CONSTRUCTION DOCUMENTS

FALCON MARKETPLACE

SF-19-001

75% SUBMITTAL 12-20-18

SECTION A-A
NO SCALE

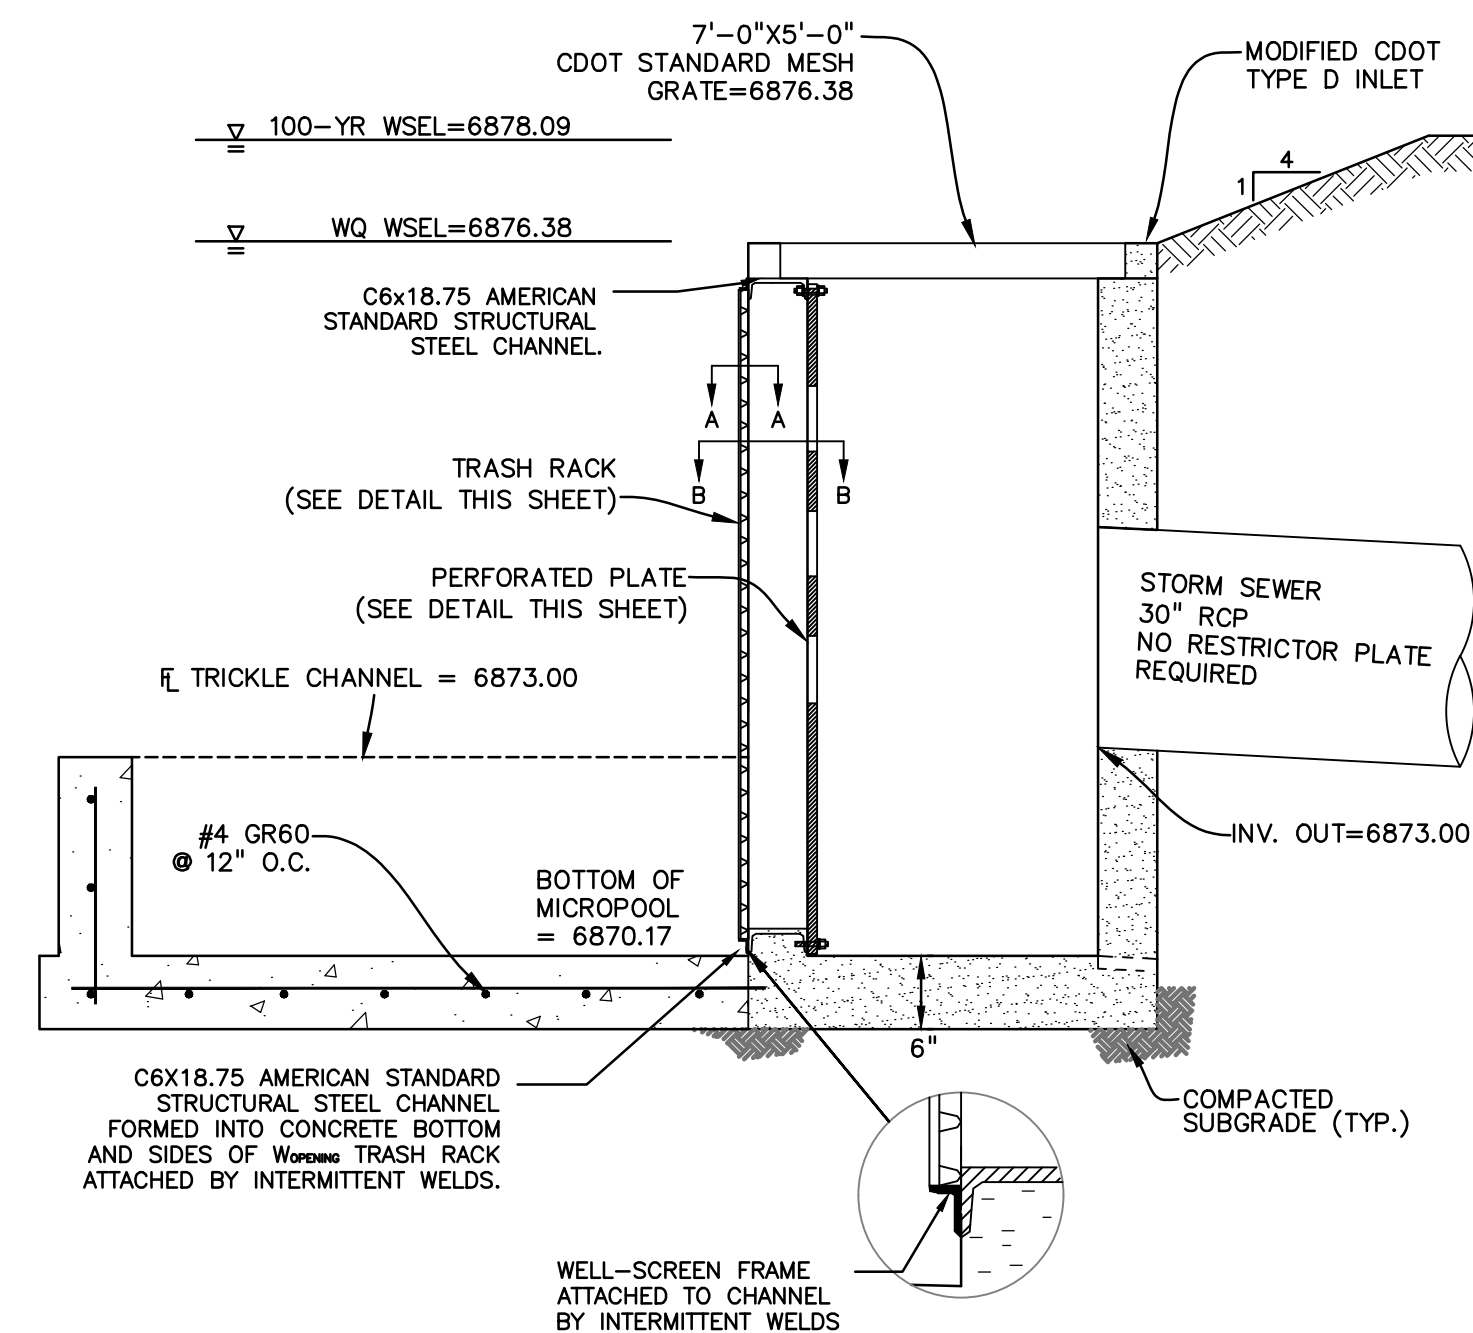
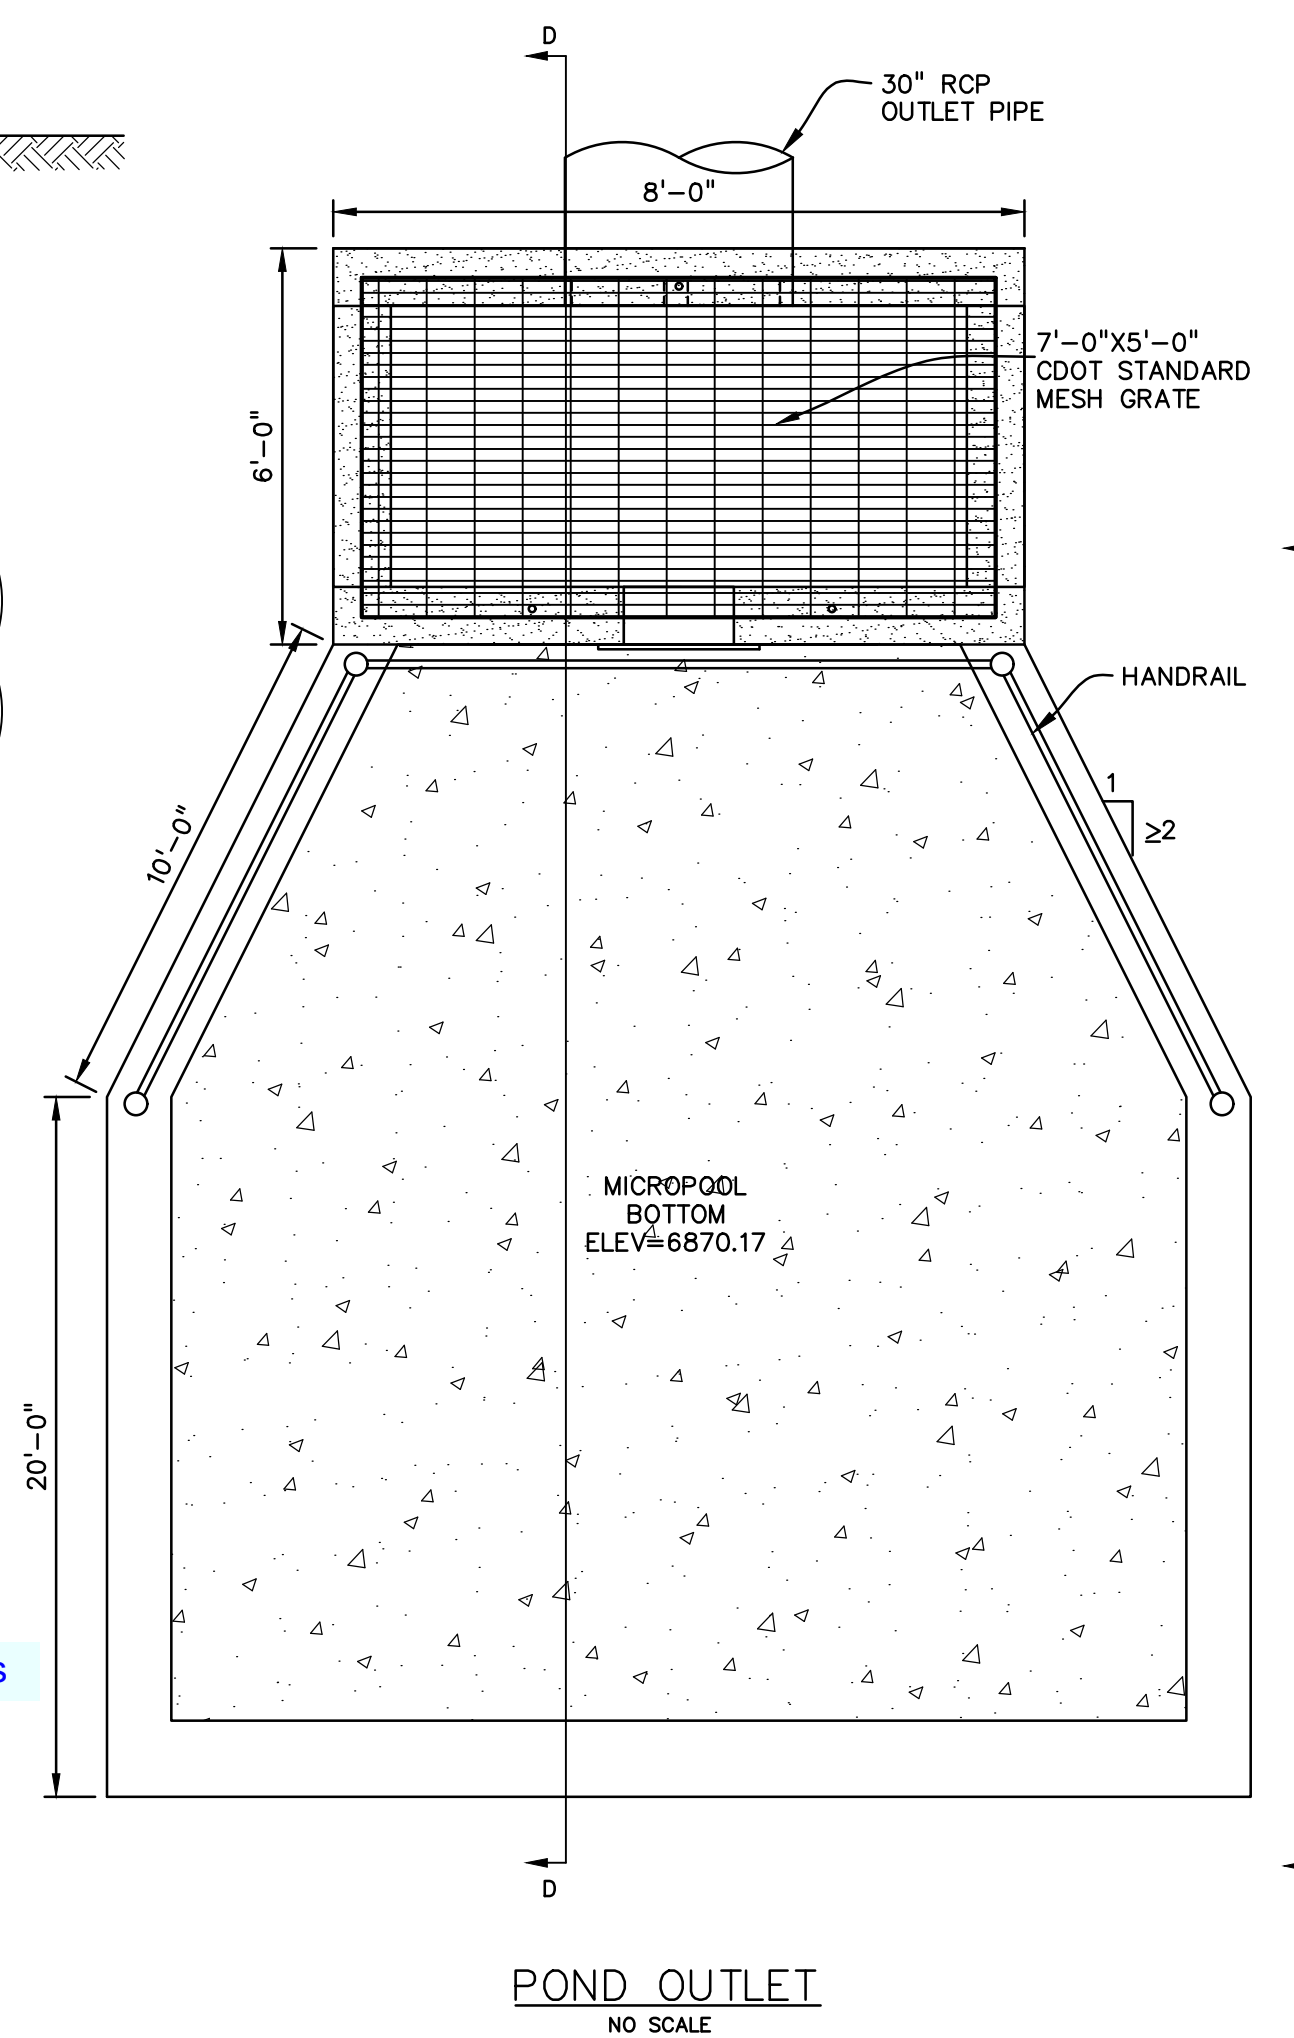
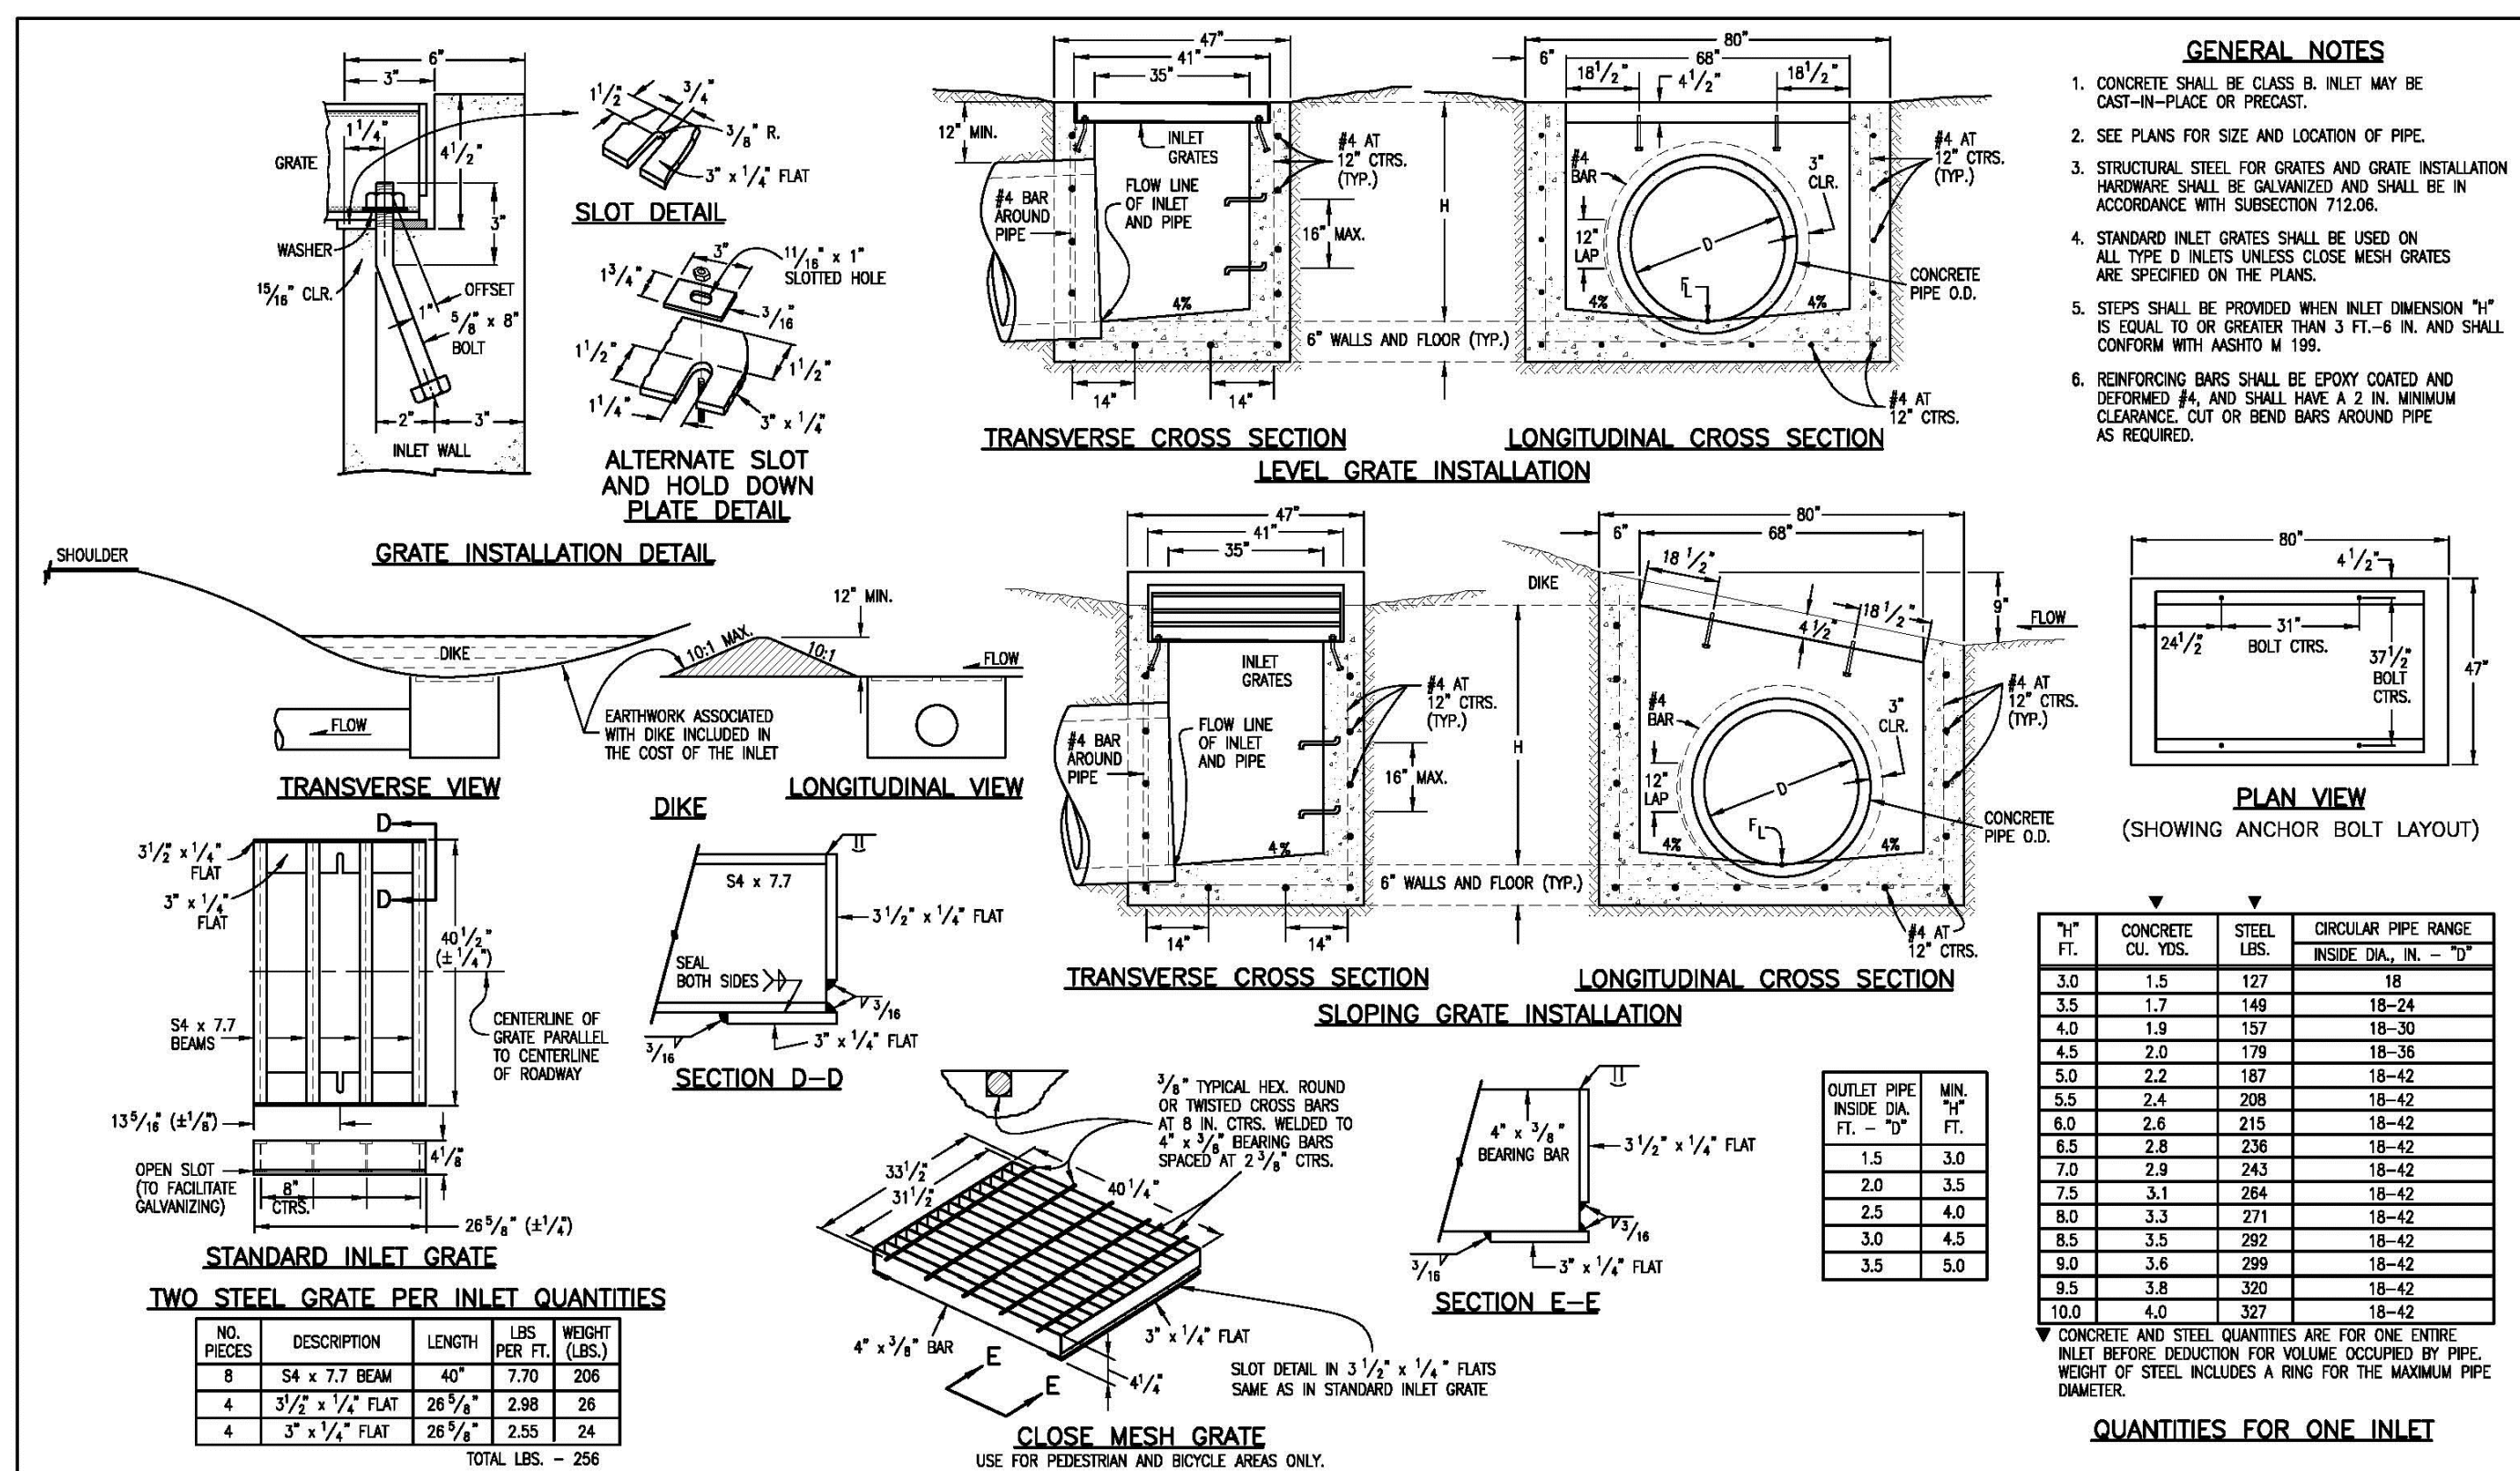
Stainless steel?
